## Remarks

Applicant respectfully requests reconsideration and reexamination. This amendment affects the claims of the above-identified application as follows:

Fig. 1  
(Prior Art)

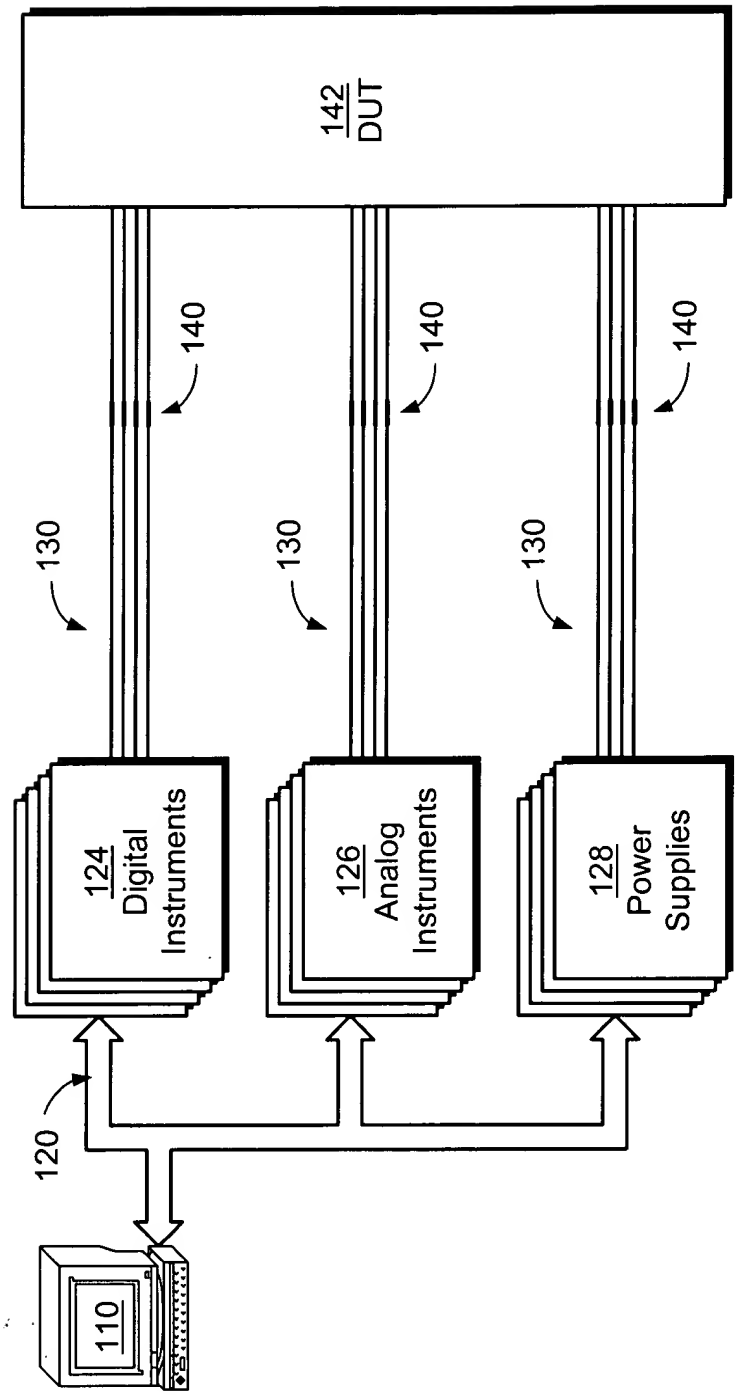
The Examiner has objected to the drawings for not indicating that Fig. 1 is prior art. Applicants have provided a marked-up copy of Fig. 1 herewith, along with a separate letter to the Official Draftsperson and a revised Fig. 1. Accordingly, this objection should be overcome.
